Chemung County Stormwater
Construction Inspection
Erosion and Sediment Control

Project Name	Biltmore Crossing Apts.	Date	8/7/14
Location	Biltmore Drive, Horseheads, NY	Permit #	NYR10X559
Weather Conditions	partly cloudy	Entry Time:	10:20 am
On-Site Representative Present:		Exit Time:	10:48 am

PROJECT:	Biltmore Crossing
	Town of Horseheads
	Municipal Inspection
	August 7, 2014

Sketch of Project site-Include Disturbed Areas: Not to scale - NOT all items drawn

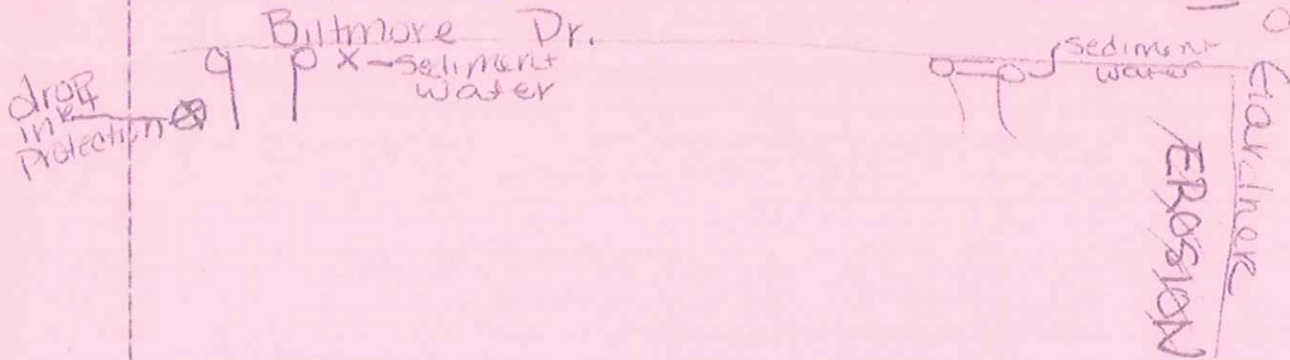
Comments: ① Sediment water is in Biltmore Drive Ditch at Upper construction entrance.

② Drop Inlet protection required at all catch basins

③ Soil Steep pile has mulch on it but needs complete cover

④ Concrete washout-water is flowing out/through downslope - ^{not} functioning because plastic not secured.

⑤ Compost sock-nearing sediment capacity. Remove sediment and/or replace

⑥ Pond-majority of vegetation is weeds. Wrong erosion blanket on

Spillway stabilization required between pond and building

⑦ Rill erosion occurring along Gardner Rd due to lack of stabilization

⑧ Construction Entrances-minor tracking onto road. May want to extend along into site due to amount of traffic.
